Subject: Description of Permissive Change

FCC ID: ZUA-AUTO-NACS01

Model Name: NACS01

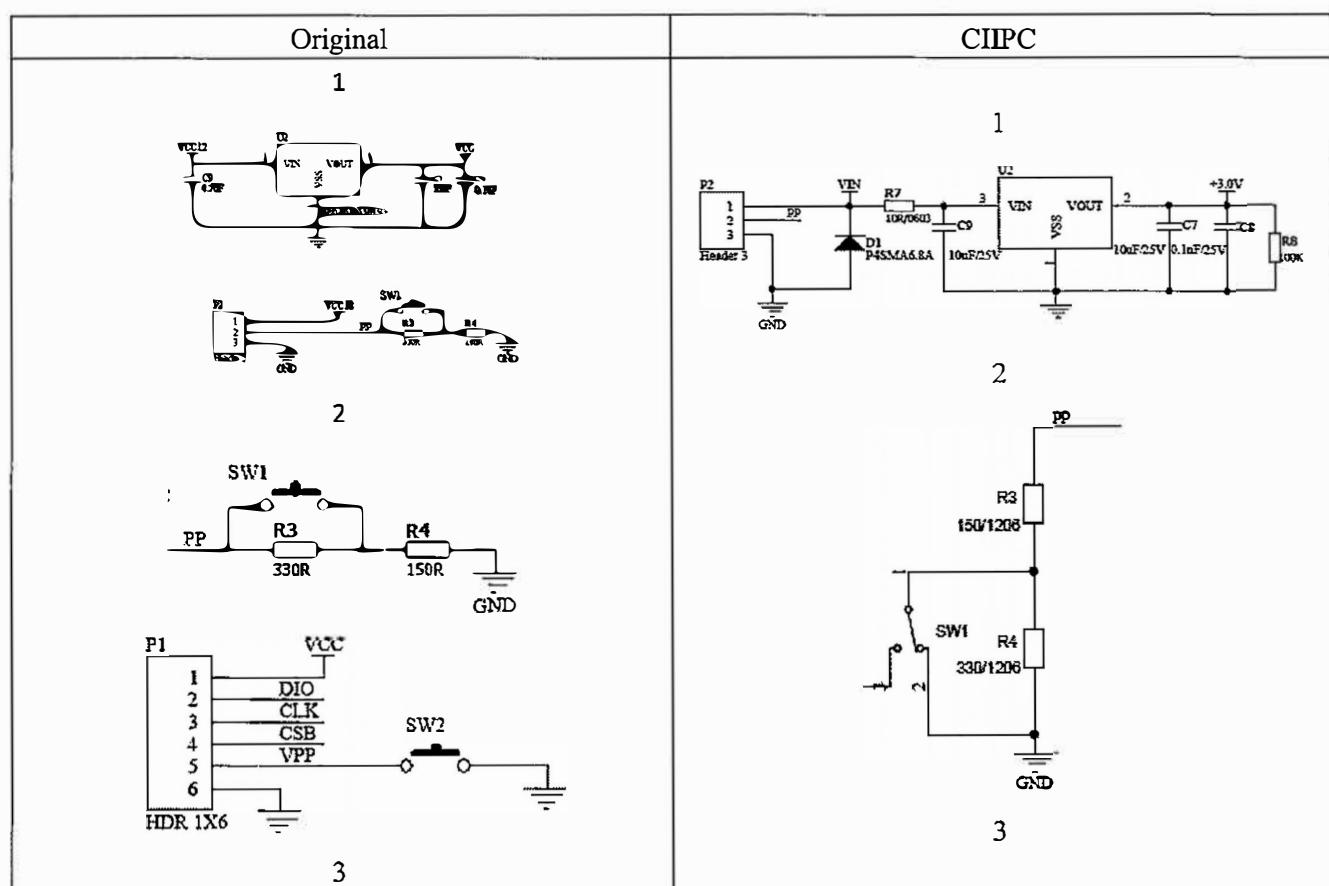
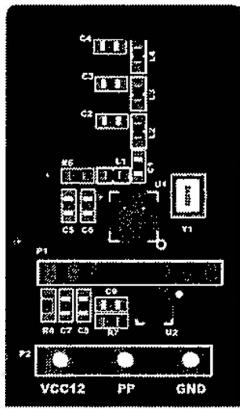
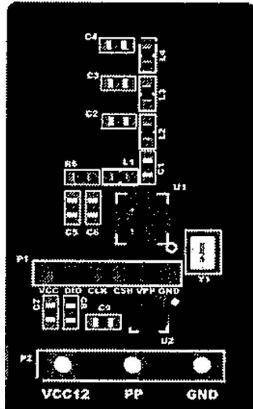
1. The power supply has been modified and some protective measures have been added, such as current limiting resistors R7, TVS tubes D1, and loads R8. It have two different version for D1, the VIN of EUT is different.

Version	D1 Model	VIN
Version 1	P4SMA6.8A	DC 3.3V
Version 2	P4SMA18A	DC 3-15V

2. The RF triggered button SW2 and the charging gun identification resistance switch button SW1 are integrated into the SPDT button.
 3. Changed the antenna size.
